Response to Comments and Clarifications

Pacoima Spreading Grounds Improvement Project City of Los Angeles, California

SCH No. 2016011026

February 2021

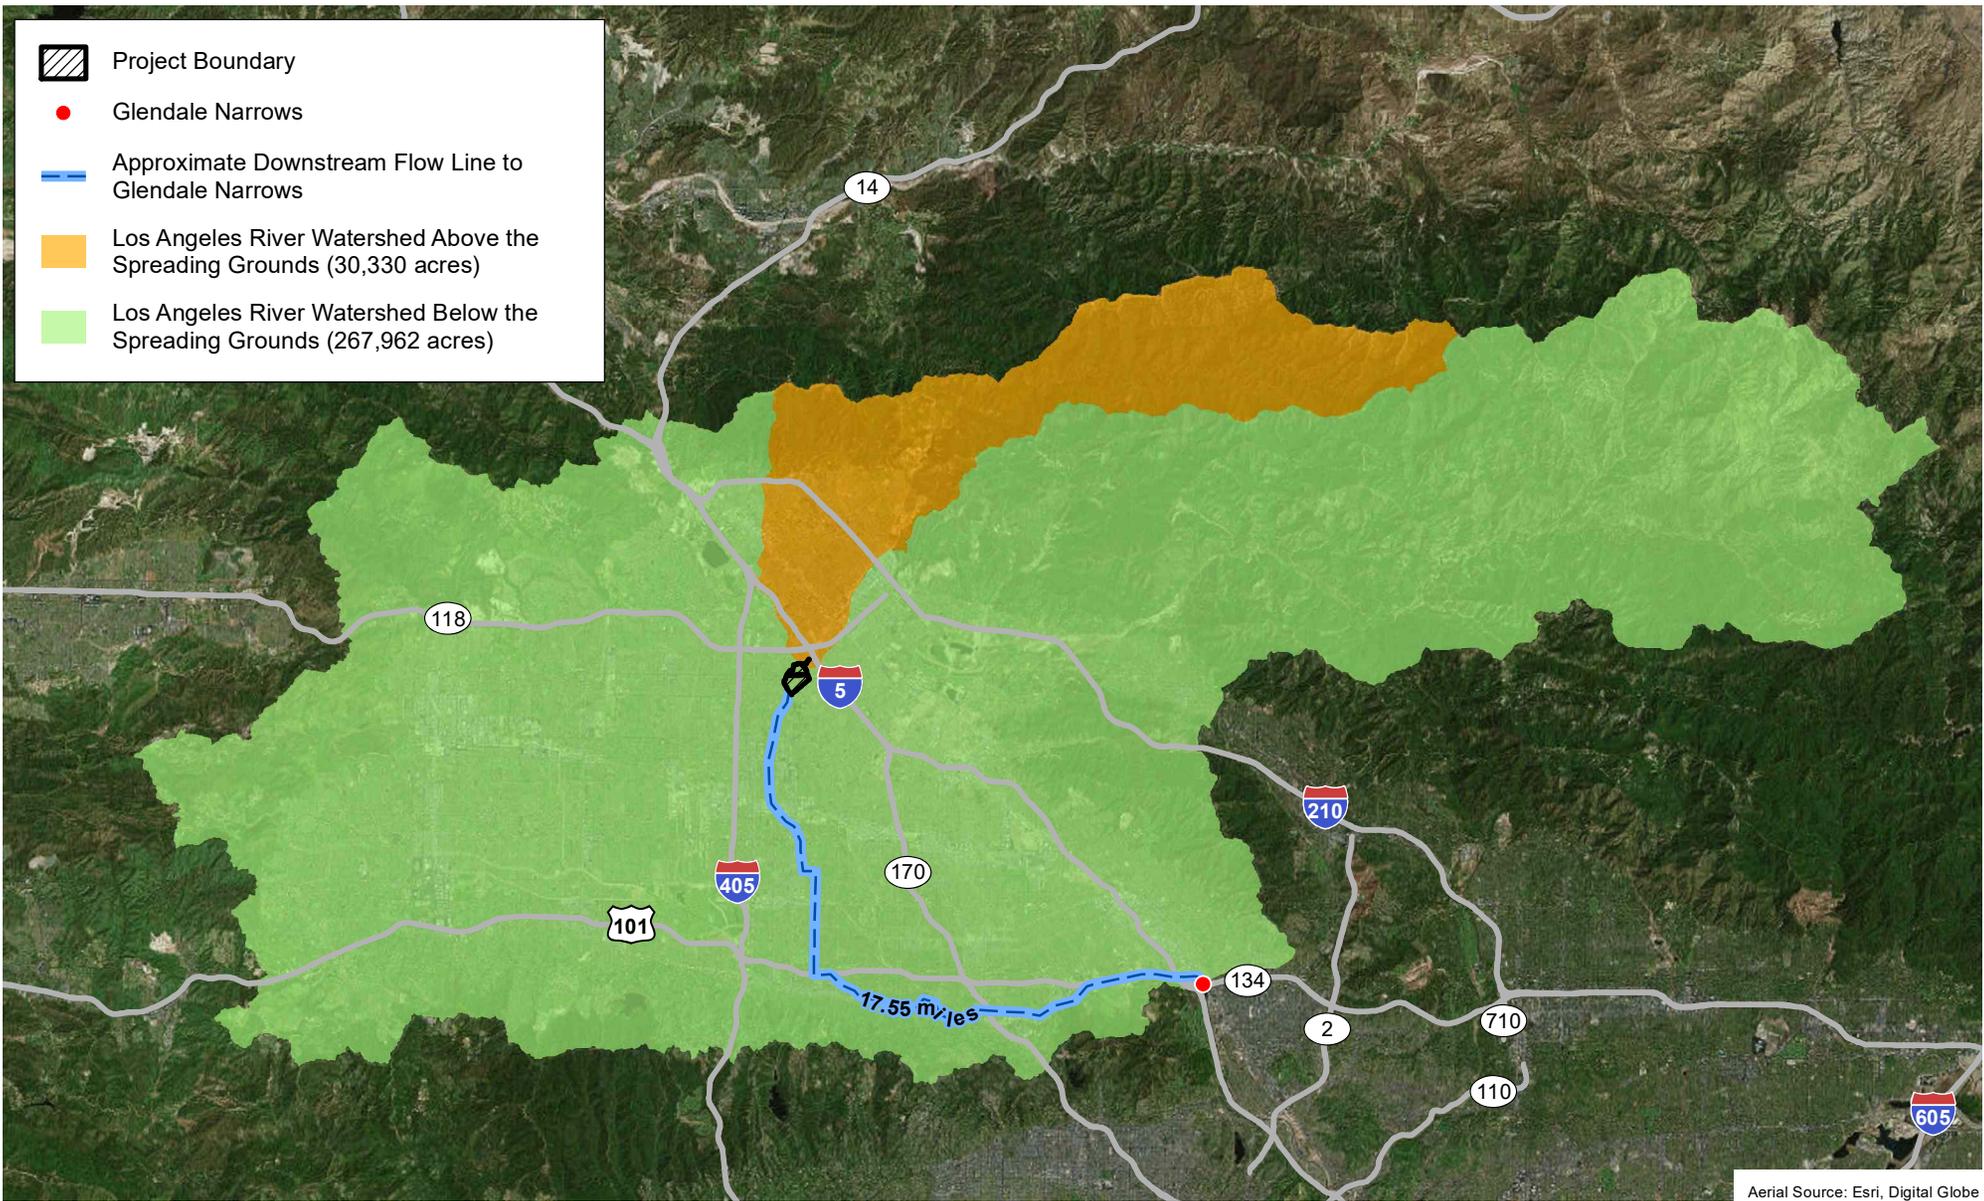
- 1) **Hydrology.** The MND should include a discussion on how this project will reduce surface flows downstream of the Project. The Department is concerned reduced surface flows could negatively affect downstream biological resources. Specifically, the Department is concerned with the biological resources within the existing Glendale Narrows section of the Los Angeles River, as well as on-going and future restoration projects under the United States Army Corps of Engineers' approved Los Angeles River Ecosystem Restoration Plan. To enable the Department to comment on the Project's potential affects to biological resources, the following information should be included in the final MND:

CDFW1-1 Thank you for submitting comments on the 2016 MND; all comments will be provided to the Board of Supervisors for consideration prior to making a decision on Project approval. Implementation of the Project is not expected to result in a change to surface flows downstream of the site that would negatively affect biological resources downstream to any measurable degree, including the Glendale Narrows section of the Los Angeles (LA) River or potential future restoration projects in the LA River approved by the LA River Ecosystem Restoration Plan.

The Project would not result in a change to surface flows that could negatively affect biological resources downstream of the site. For example, it is recognized that the Glendale Narrows section of the Los Angeles River has vegetation that has persisted without active management by the U.S. Army Corps of Engineers. However, the increased diversion into the Pacoima Spreading Grounds resulting from the Project, of up to 10,500 acre-feet per year (in a wet year), would not adversely affect the biological resources of the Glendale Narrows section for the following reasons.

In addition, the further the distance between a reduced flow regime created by a diversion and the downstream vegetation that may be supported by that flow, the less effect the change in flows would typically have on that vegetation. This is because the amount of downstream flow reduction, resulting from the diversion, represents a smaller and smaller percentage of the total downstream flow reaching the vegetation as additional flows enter the drainage system downstream of the diversion. Regarding the Project in particular, there are innumerable additional inflows to the channel and the Los Angeles River over the approximately 15 linear miles between the diversion point and the Glendale Narrows section of the Los

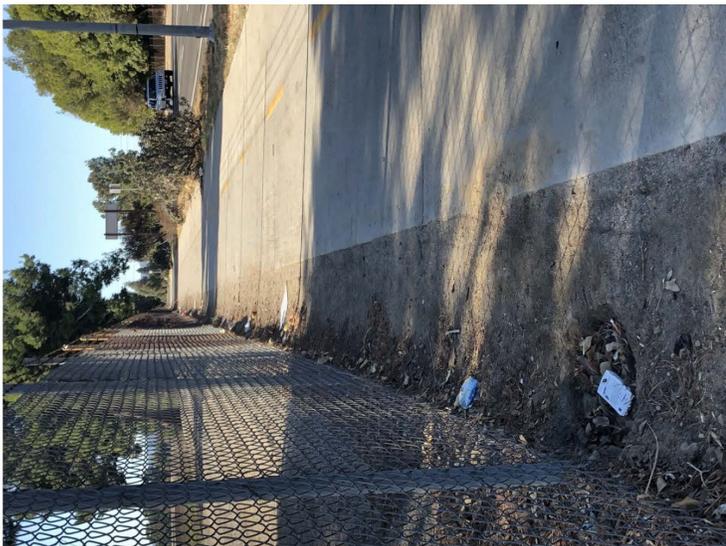
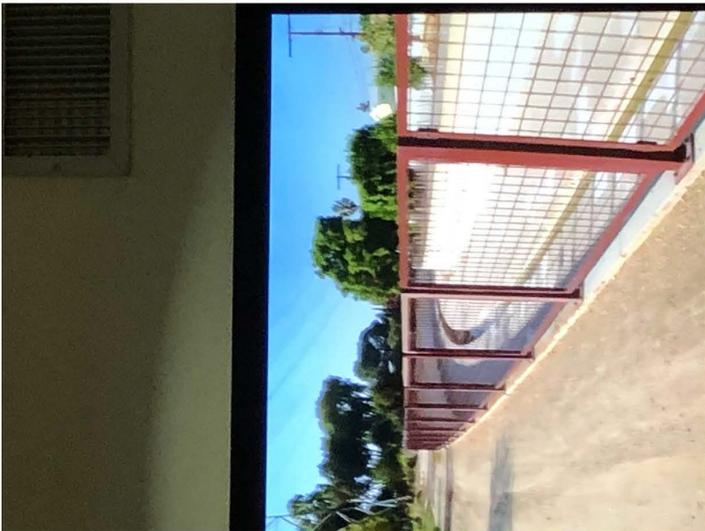
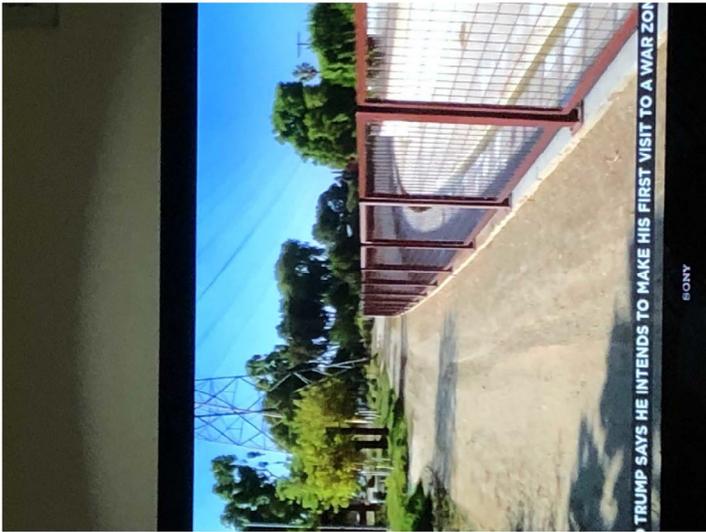
This is what I'm referring too, see pictures below. Our beautification efforts pick up the trash on a regular basis when it rests beside the chain link fence.

This is a better option than tubular fencing. Installing it next to where the basin sinks will allow more walkable space for recreation. We want to have public access to the fire road or driving path. 2 cont.

Picture 2.

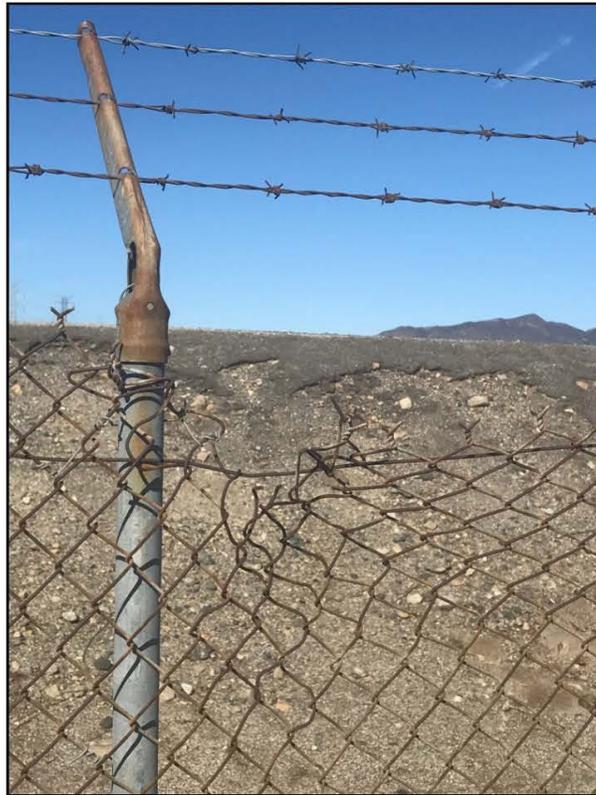
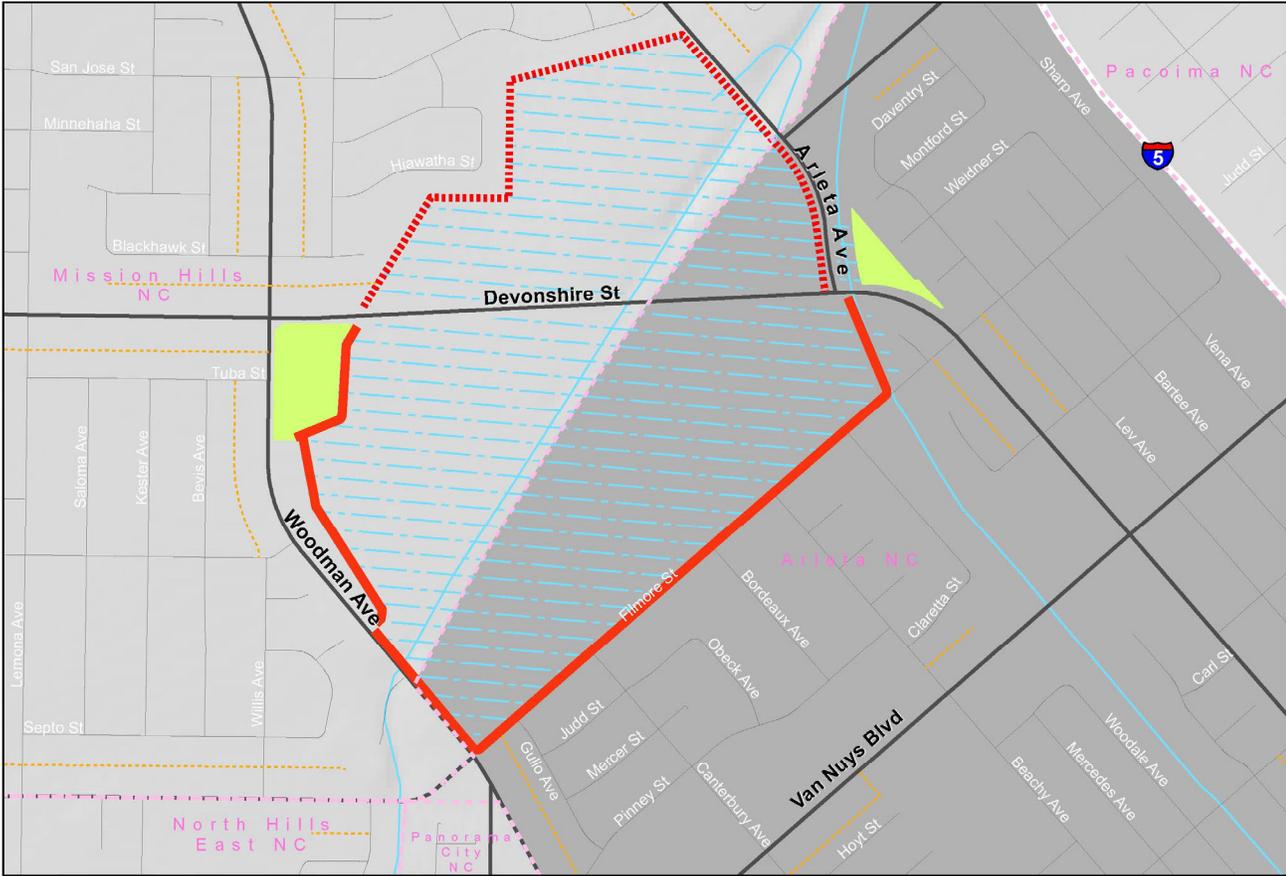
Dumped garments and trash on spreading grounds property Woodman Avenue side.

Styrofoam cooler and trash from individuals drinking beer or other in vicinity, Woodman Avenue side.

Point used for climbing/stepping on fence to trespass into the spreading grounds, Filmore Street side.

Missing barb-wire at fence at 10230 Woodman Avenue, Mission Hills, CA. Devonwood Park, innermost corner.

Breach at junction with City of Los Angeles Recreation & Parks' equipment storage area fence.
Devonwood Park, 10230 Woodman Avenue, Mission Hills, CA 91345.

Exhibit 4-1

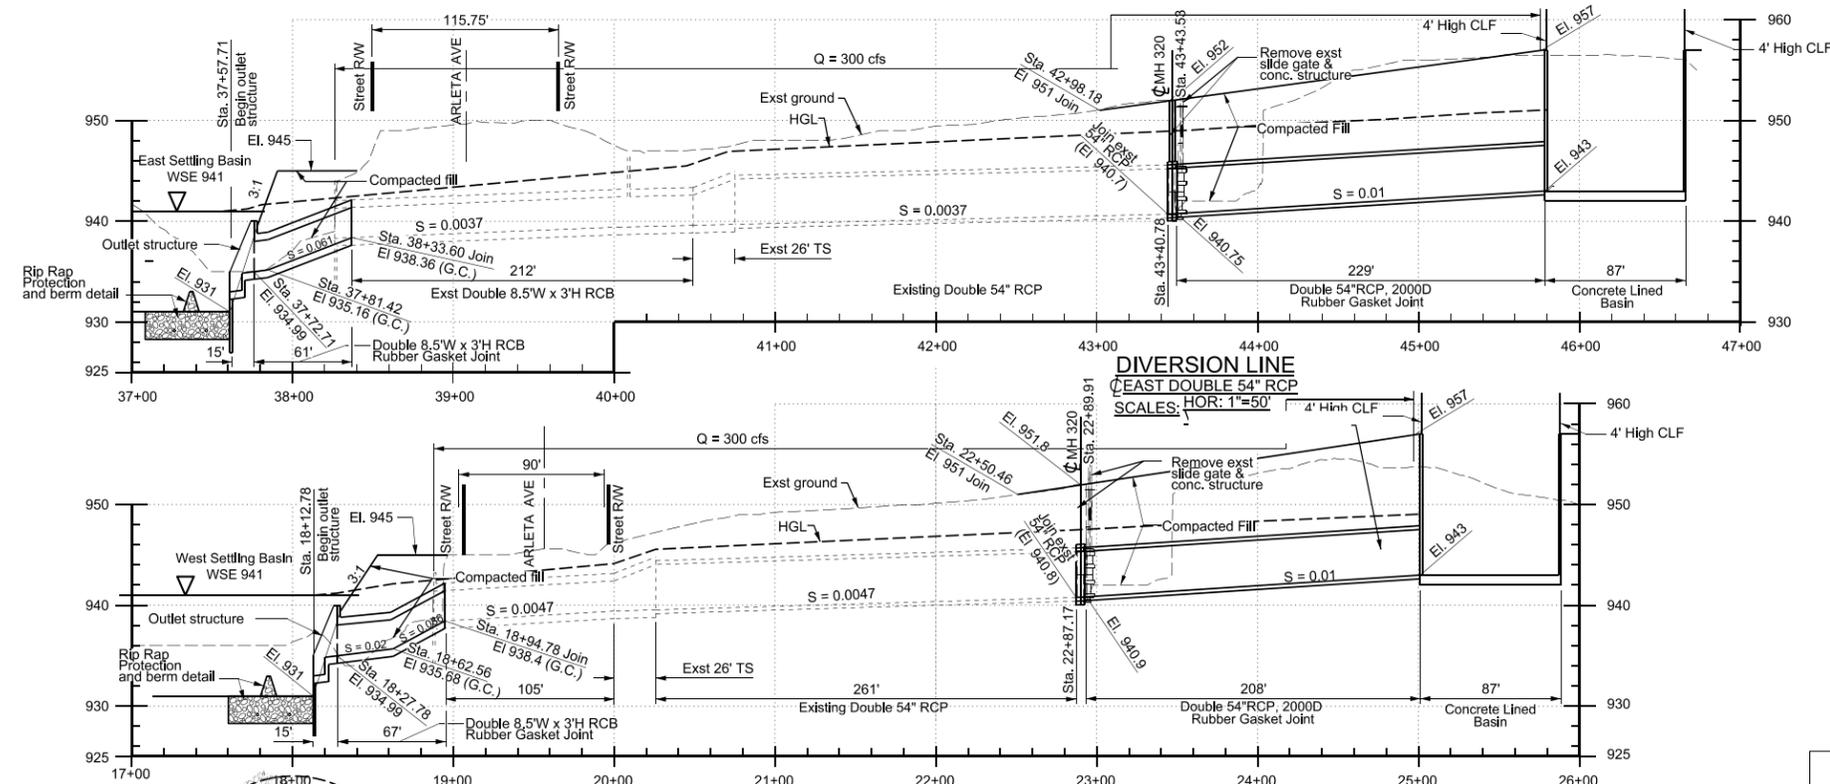
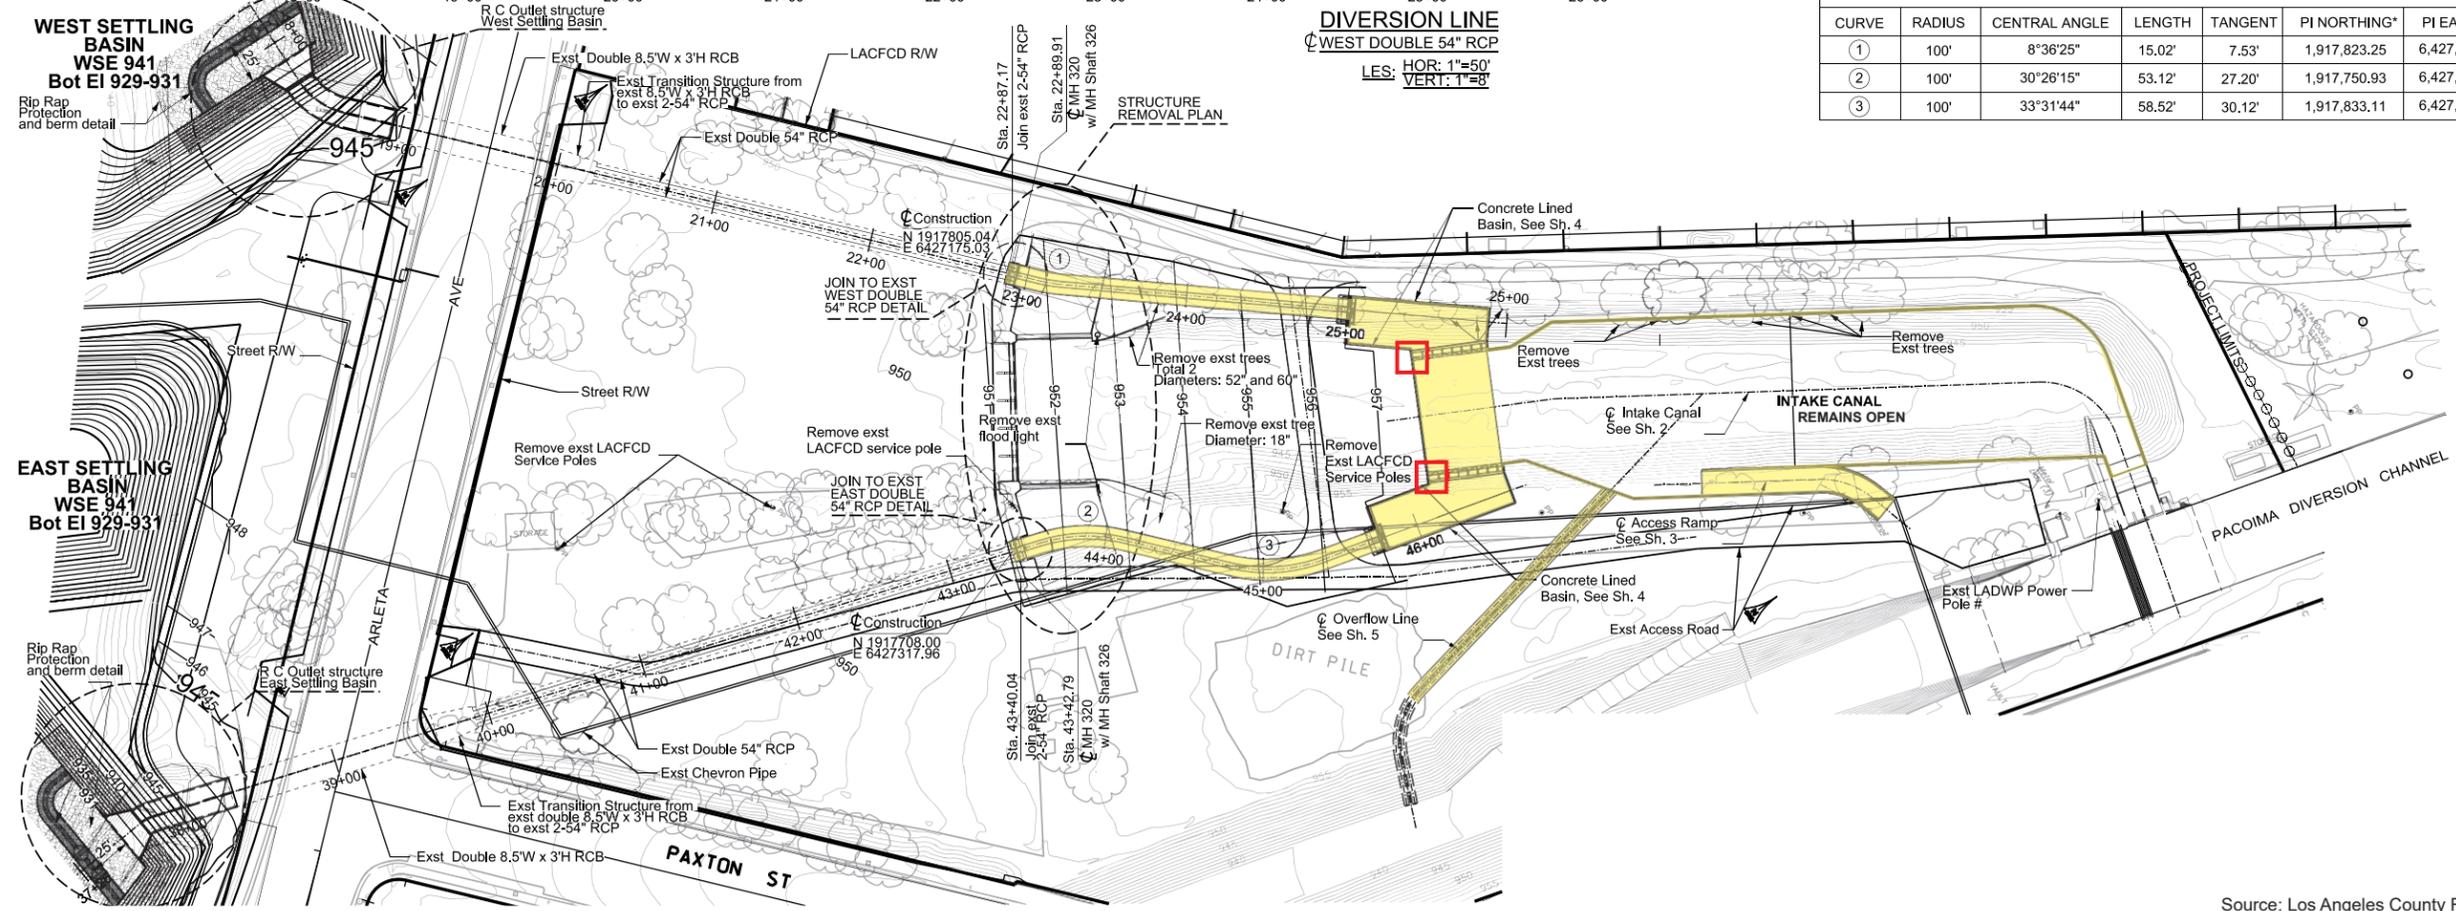
Subsequent to circulation of the Recirculated MND, LACFCD determined that the intake canal design addressed in the Recirculated MND would need some modifications to ensure appropriate long-term maintenance and operation. Principally, it was determined that complete coverage of the intake canal would pose a substantial maintenance challenge to access the subterranean infrastructure and remove the large quantities of sediment, trash, and other debris that enter the intake canal in runoff and would accumulate over time. After further consideration of engineering and operational constraints, it was concluded that a partially open intake canal would be a preferable option as it would provide the following benefits:

- Ease of maintenance, including debris removal;
- Improved percolation rate;
- Reliable flow measurement; and
- Operational flexibility.

As a result, the design was modified to a partially open intake canal. The intake canal design addressed in the Recirculated MND (as Exhibit 2-5) is provided here as Exhibit 4-1, 2018 Recirculated MND Intake Canal Design, and the proposed intake canal redesign is provided here as Exhibit 4-2, 2020 Intake Canal Redesign. On Exhibit 4-2, the areas that are different in the 2020 design compared to the 2018 design are shaded in light yellow.
